Entergy Nuclear Operations, Inc.
(Indian Point Nuclear Generating Units 2 and 3)

NUREG-1740

Voltage-Based Alternative Repair Criteria

A Report to the
Advisory Committee on Reactor Safeguards
by the
Ad Hoc Subcommittee on a
Differing Professional Opinion

Figure 3. Schematic Diagram of Natural Circulation in the Primary Reactor Coolant System. On the left, full loop natural circulation is shown. On the right, countercurrent natural circulation through the steam generator is shown.

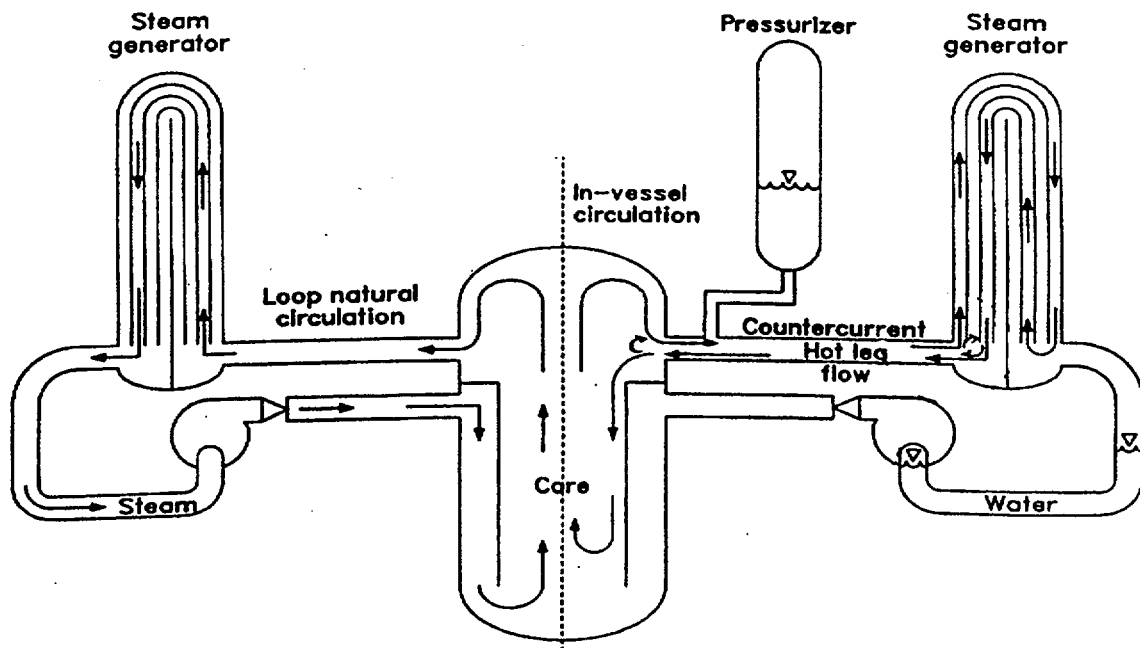
The staff has analyzed the possible evolution of severe accidents and the loads that they place on the steam generator tubes using computer models like SCDAP-RELAP5. These analyses [5] are predicated on the assumption that the "loop-seals" in the primary reactor coolant system remain in place, so there is not a gross convection through the reactor coolant system³. Instead, a countercurrent natural circulation of steam from the degrading reactor core through the steam generator tubes and back to the core is established. A schematic diagram of this natural circulation flow is shown in Figure 3. The analyses done by the staff indicate that heat is transferred to other parts of the primary reactor coolant system by the natural circulation flow, and failure at other locations is likely to occur before a steam generator tube undergoes gross failure as a result of creep rupture. Typically, the surge line is predicted to fail first, followed by failure of a reactor nozzle. The analyses also show that the timing of the failures at the various locations are not greatly different.

³ If a loop seal is opened and the coolant level in the pressure vessel is sufficiently low, an overall natural circulation of high-temperature steam through the steam generator and back into the vessel develops (see the left side of Figure 3.) This overall natural circulation is thought to impose sufficiently high heat loads on the steam generator tubes that the tubes fail whether they are flawed or not. Detailed analyses have not been done, but it is known that additional complexities can develop in the analyses of such scenarios, including episodic re-establishment of the loop seals.

The Ad Hoc Subcommittee concluded that the issue of the possible evolution of severe accidents to involve gross failure of steam generator tubes and bypass of the containment is not yet resolved. The Subcommittee also believes that the issue needs consideration regardless of the criteria adopted for the repair and replacement of steam generator tubes. The issue may be affected by any enhanced leakage that comes from the use of the alternative repair criteria described in GL 95-05. But, the issue is just one of several significant uncertainties that now exist in the assessment of severe accident progression.

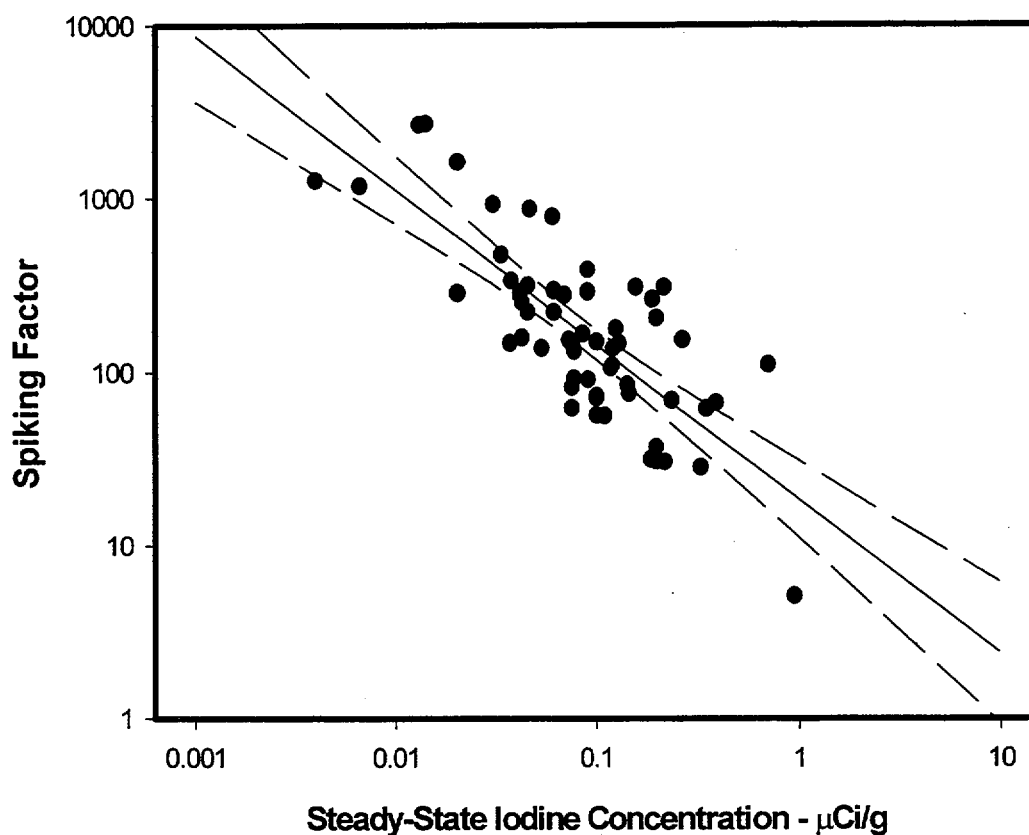
The DPO author contends that the spiking factor used for the accident analyses is too low when the Technical Specification limit on the iodine concentration in the coolant during normal operations has been reduced. He argues that the spiking factor increases with decreasing steady-state iodine concentration. Data collected and reviewed by Atwood and Sattison [17] substantiate the claim made by the DPO author (See Figure 6). A phenomenological understanding of this correlation

where $N = 58$ is the number of data points used to construct the correlation. These bounds are indicated in Figure 6 by the dashed lines on either side of the solid line calculated from the correlation.

The DPO author rightly contends that the iodine spiking factor seems to exhibit a correlation with the initial iodine concentration in the coolant. But, it might be argued that for accident analyses the appropriate spiking factor to use is that found from the empirical correlation using the actual operational iodine concentration rather than the Technical Specifications limit adopted by the licensee, whether it is 1.0 $\mu\text{Ci/g}$ or 0.01 $\mu\text{Ci/g}$. Such a procedure would be inconsistent with the approaches that have long been used in the analysis of design basis accidents. The Ad Hoc Subcommittee also believes that the empirical, linear correlation of spiking factor with initial iodine concentration to the very low initial iodine concentrations typical of many plants today without explicitly accounting for data uncertainties and variations in the mechanisms that lead to operational levels of iodine in the coolant is without sound technical foundation.

Data are available to develop a correlation of the spiking factor with steady-state iodine concentration for analysis of steam generator tube rupture events. If this is done, the correlation should be used with whatever Technical Specification limit on the iodine concentration has been adopted by a licensee rather than the operating iodine concentration typical of the plant. This will maintain consistency with past practices in the analyses. If the staff continues to believe that the spiking factor is greater in a main steamline break because of high differential pressures, another specification of the spiking factor needs to be developed. The Ad Hoc Subcommittee believes, however, that it would be better for the staff to develop a more realistic mechanistic understanding

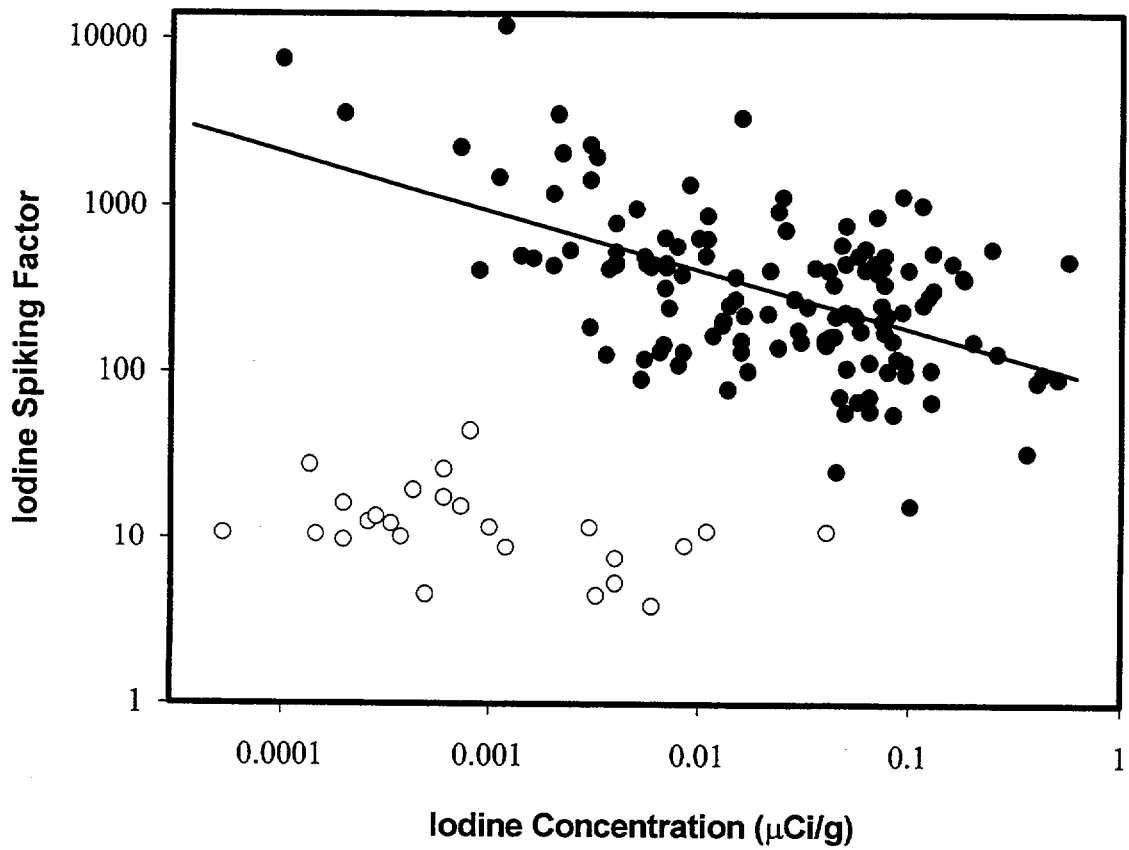
The staff provided the Ad Hoc Subcommittee with an expanded data set on spiking factors. The pedigree of this database is uncertain, but it definitely is not the database used to prepare plots of spiking factor as a function of the initial, steady-state iodine concentration of the coolant shown to the Subcommittee and included in the staff's responses to the DPO. This database seems to be composed of two populations (See figure 7). In one population, the spiking factor does exhibit a dependence on the initial, steady-state iodine concentration. Spiking factors from the other
